RE: Petition for Reconsideration of Final Rule NHTSA Docket 2023-0021

Legal and Engineering Support of Petition for Reconsideration of the Final Rule Adopting Requirements for Automatic Emergency Braking

NHTSA Docket 2023-0021

Figure 1 - Surface friction versus surface temperature example

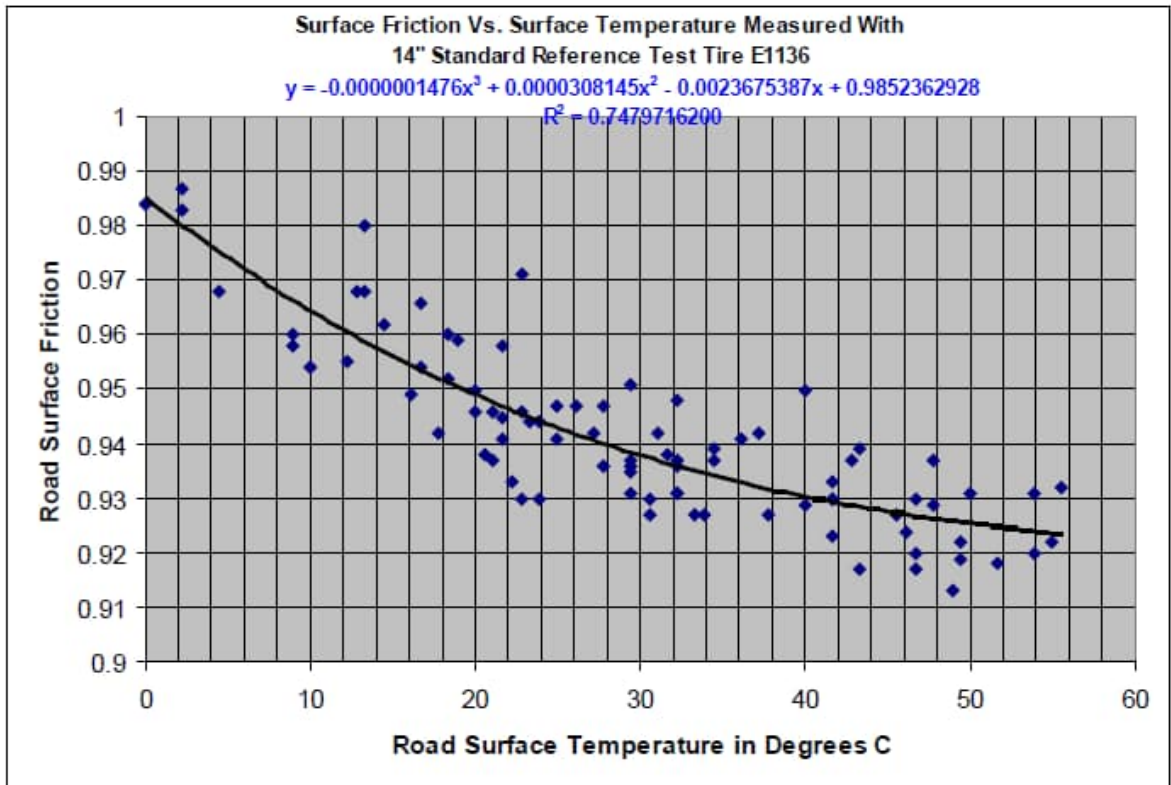
The figure below, from SAE J2909, “Light Vehicle Dry & Wet Stopping Distance Test Procedure” demonstrates the range of surface frictional coefficients that can occur across the allowable ambient temperature range specified in the Final Rule (0° C - 40° C).

In addition to temperature, other ambient conditions contributing to test performance variation include things like cloud cover (or intermittent cloud cover, especially), dust, debris, pollen effects, recent rainfall, and other noise factors. These variations in ambient conditions can easily translate into about 8-10 feet (2.5-3m) or more variation in absolute stopping distance on any given test surface.

Figure 30: Distribution of TTC for Nissan Altima for S1 Tests Conducted at 16 km/h

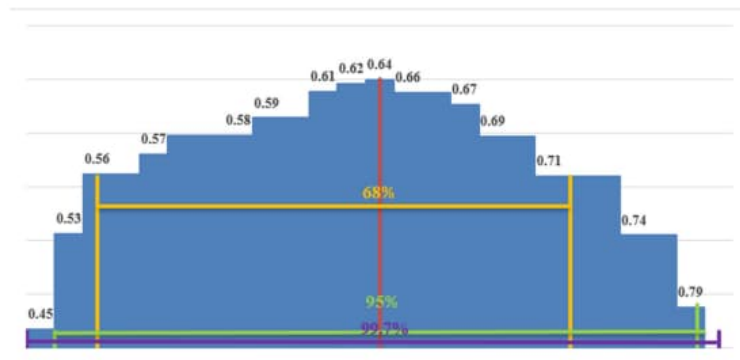
was assessed at the Final Rule speed of 62.1mph (100 km/h). Even at these lower speeds, the NHTSA data show a variation of at least 0.15 seconds in TTC, in addition to any other stacking variations due to test set up and other variables. Below are three figures from NHTSA's FRIA showing this variability:

Figure 32: Distribution of TTC for Subaru Outback for S1 Tests Conducted at 40 km/h

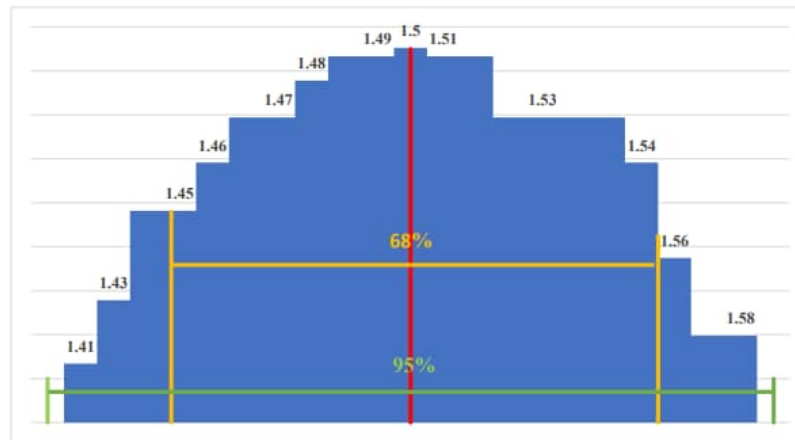
When these data are considered in the context of the requirements of the Final Rule, the practicability problems become clear. The following example illustrates the problem:

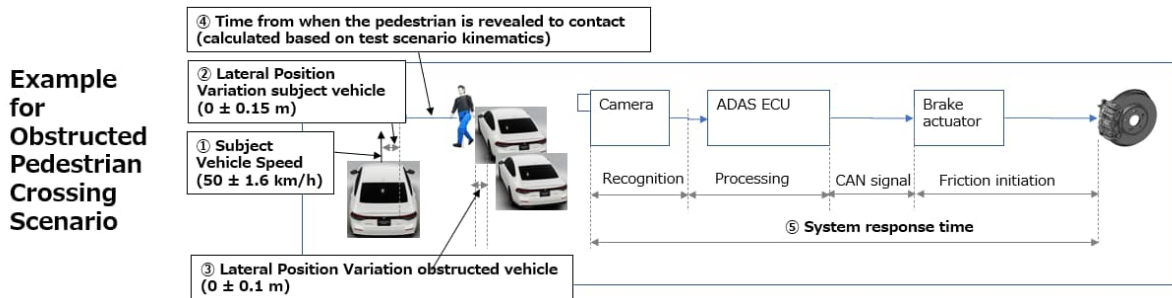
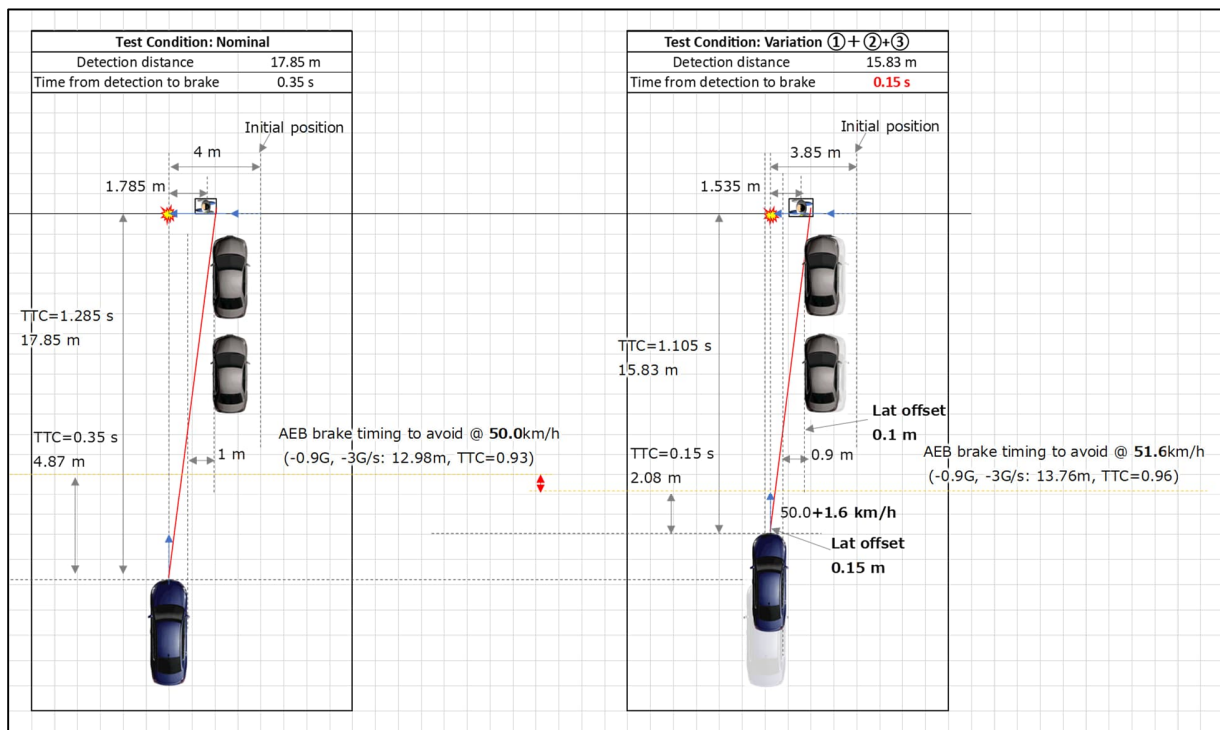
For the obstructed pedestrian crossing road scenario required in S8.2, assuming the following:

- Variation in subject vehicle test speed of $31 \text{ mph} \pm 1 \text{ mph}$ ($50 \text{ km/h} \pm 1.6 \text{ km/h}$) as specified by S7 of the Final Rule (tolerance 1 in the chart below);
- Variation in subject vehicle lateral position (overlap to pedestrian) of $0 \pm 0.15 \text{ m}$ as specified by S8.1.2 (tolerance 2 below);
- Variation in the lateral position of the obstructing vehicles (with respect to pedestrian position) of $0 \pm 0.1 \text{ m}$ as specified by S8.3.3 (tolerance 3 below); and
- AEB can achieve peak braking deceleration of 0.9 G with an initial braking input rate of 3 G per second . This is considered ideal best case but for the purposes of this example, variation is not included.

Under nominal test scenario conditions, the pedestrian is revealed from behind the obstructing vehicle at 1.285 seconds TTC, which demands that the AEB system respond (recognize, process, signal, and initiate braking friction) within 0.35 seconds to avoid contact (i.e. 0.93 sec TTC at brake activation). However, considering the aforementioned variation in testing choreography for speed and position, the pedestrian is revealed in as little as 1.015 seconds TTC. Therefore, the Final Rule actually demands 0.15 seconds response time, which is well beyond the capability of any known AEB system.

These theoretical variations in calculated AEB system response times directly support the TTC variation that NHTSA highlights in the FRIA. Together, these demonstrate that the Final Rule TTC requirements (i.e. AEB system response times) are not practicable for the current fleet.
